Re: Preliminary Land Development Submission
Proposed Development
355 Maple Avenue
Lower Salford Township
Montgomery County, PA
PAC220039.00

Below please find an itemized response to the Preliminary/Final Land Development Review #2 received from McMahon Associates, Inc., dated March 30, 2023. Our responses are noted in **bold**.

Below please find an itemized response to the Preliminary/Final Land Development, Second Review received from CKS Engineers, dated March 31, 2023. Our responses are noted in **bold**.

SHEET TITLE:
**OVERALL SITE
PLAN**
RECORD PLAN 3 OF 4
SHEET NUMBER:
C-300
4 OF 20
REVISION 2 - 06/08/2023

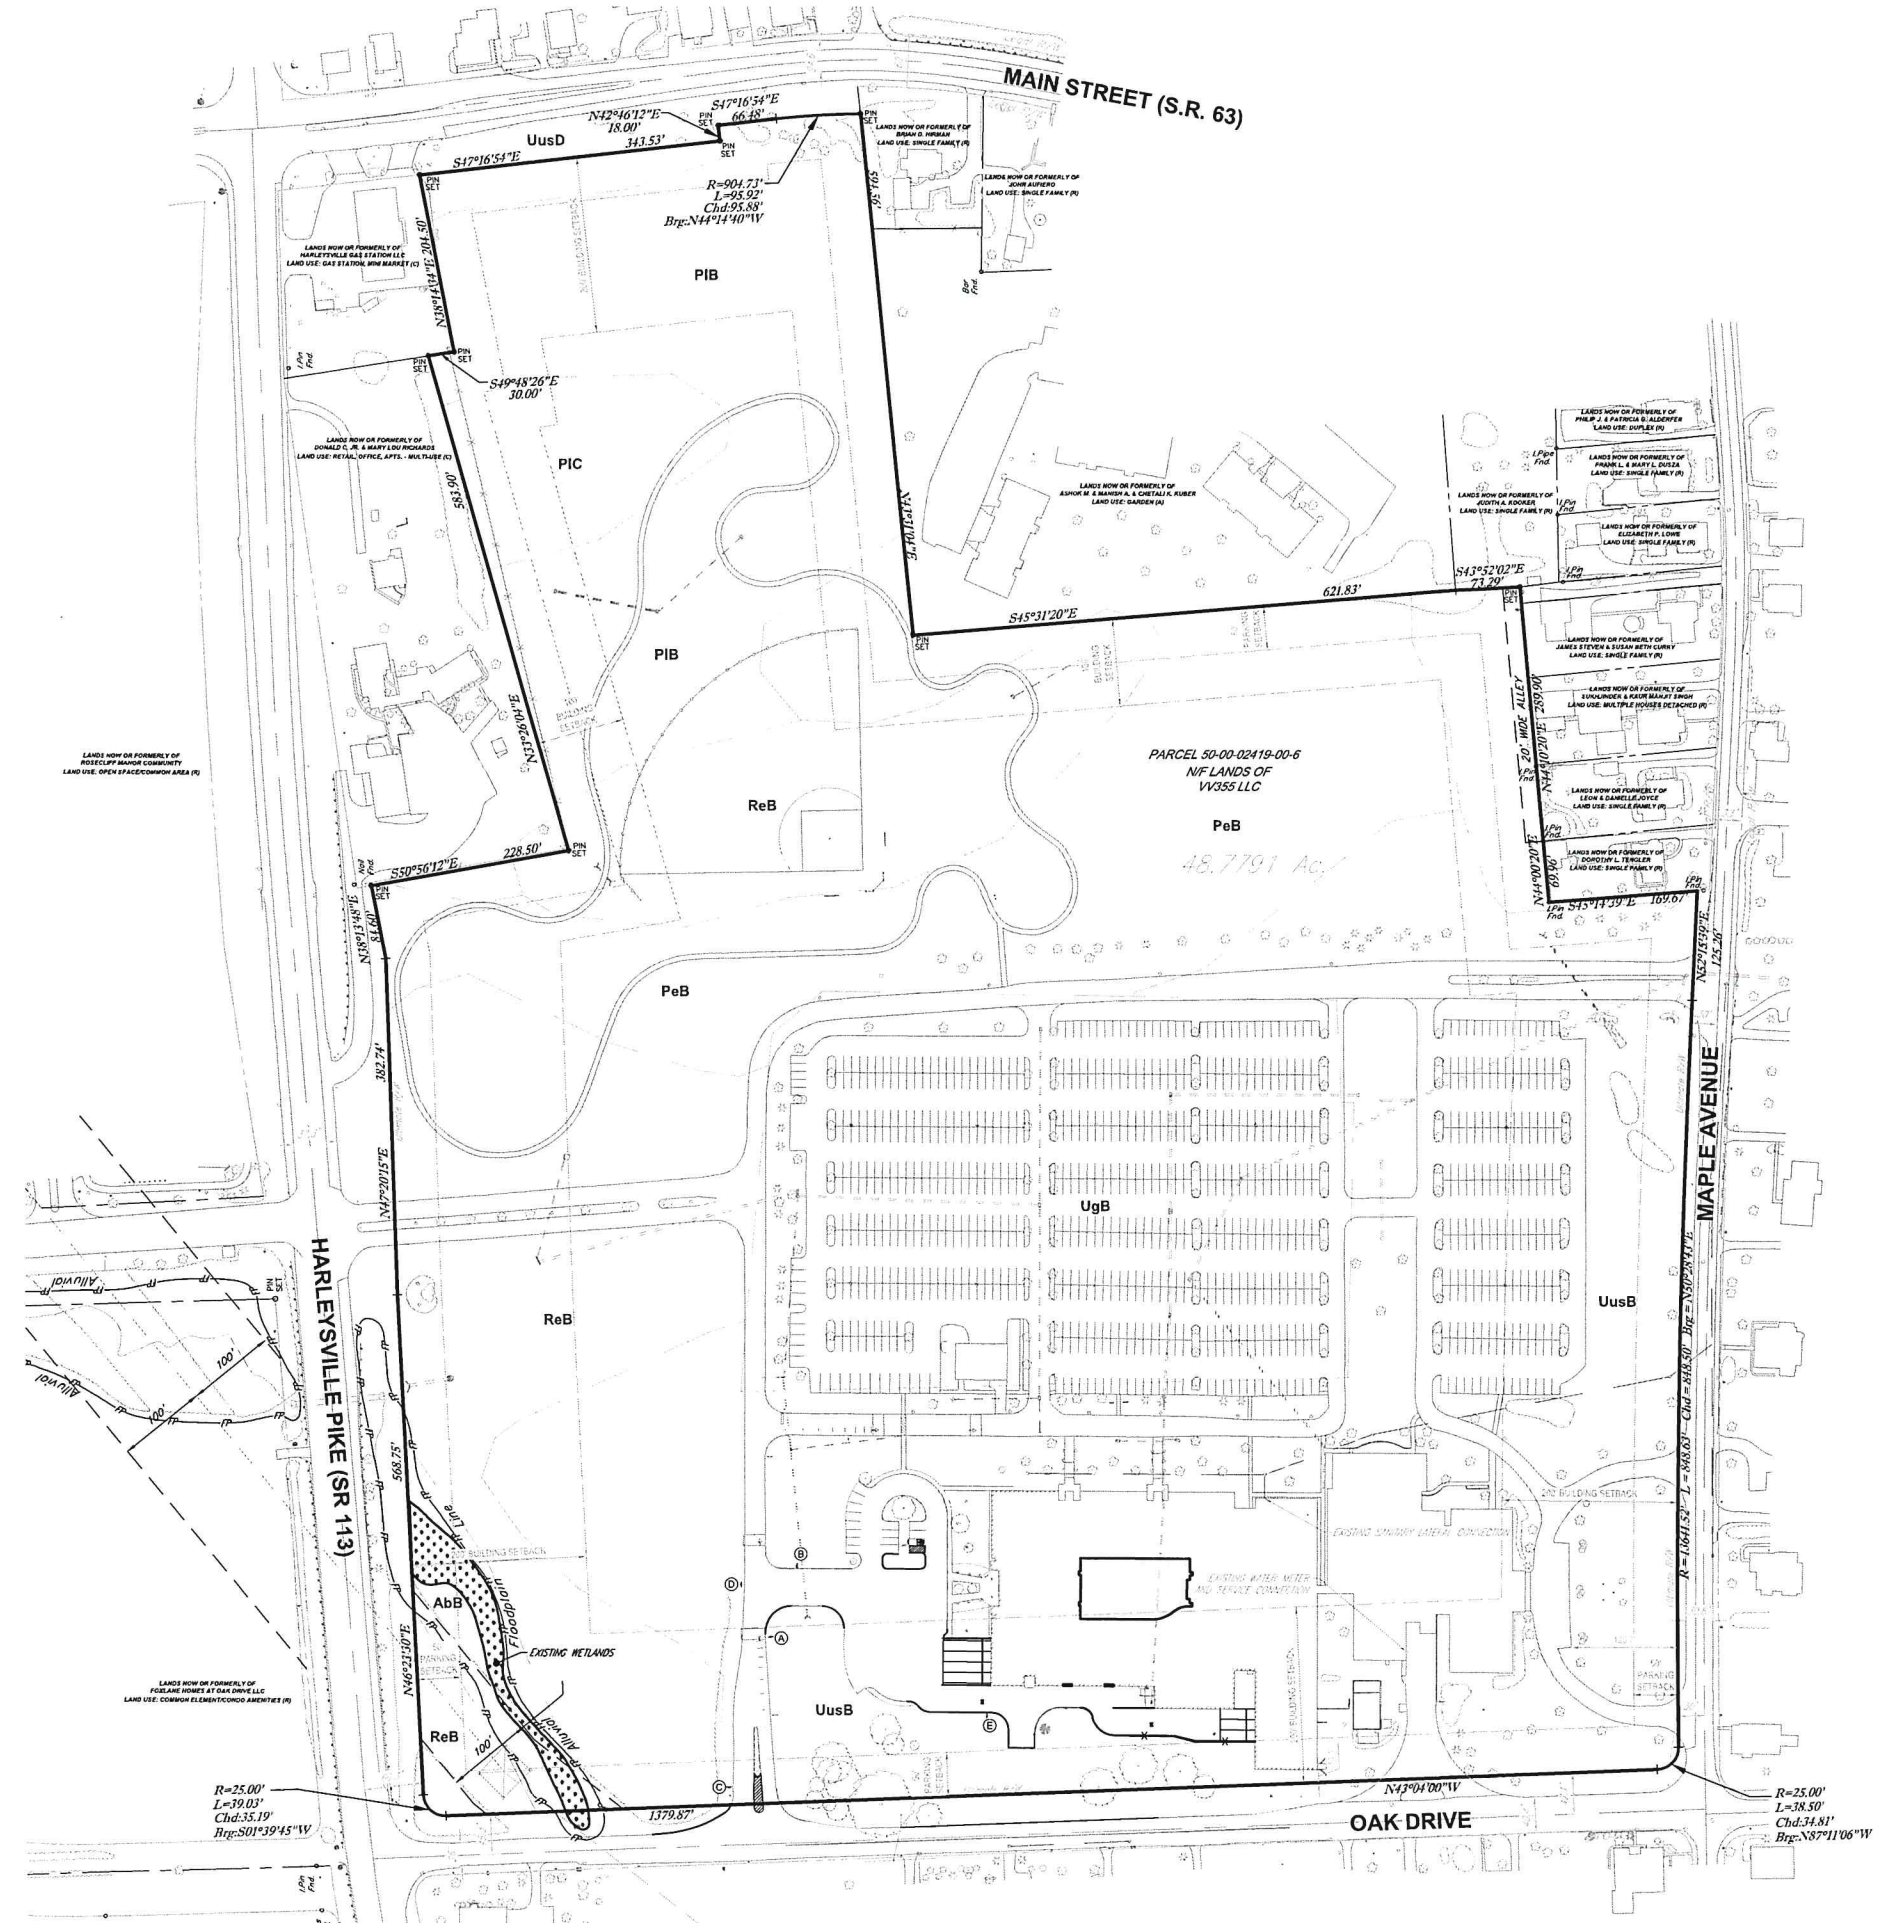
2. The land uses of immediately adjacent lands must be listed on the Site Plan. While adjacent property owners were added to Sheet 4 (C-300), some appear to be inconsistent with Montgomery County parcel records. (142-15.B.10)

3. The rights-of-way and cartway widths of all streets bordering the parcel must be listed on the plans, including the narrower width along Oak Drive. (142-15.C.1 and 142.29.E)

6. The street tie-in to the nearest intersection must be shown on Sheets 3 through 5. (142-15.D.1.a.7)

Response: Land uses for the adjacent properties have been added to Sheet 4. The landowners of these properties have been updated to match the Montgomery County parcel records.

Response: The rights-of-way and cartway width of all bordering streets are listed on the plans. See Sheet 4.

Response: The street tie-in to the intersection of Harleysville Pike and Oak Drive is now shown on Sheets 3 through 5.
